Access Compliance Report

Public Rights-of-Way

Intersection ID: 3373	Main Street: KATELYN_DR	Cross Street: PROSPERITY_CHURCH_RD	Location: W
ADA ID: 2BB7F15B57D6	Ramp Type: Para	Initial Pass/Fail: Fail	Overall Compliance: No
		Severity Score: 1.25

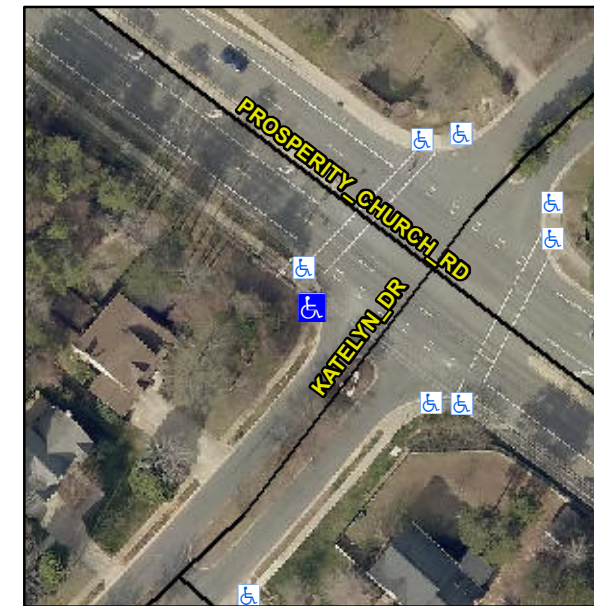
Possible Solutions:

Remove & Replace Entire Ramp.

PROW/ADA:

R304.5.3
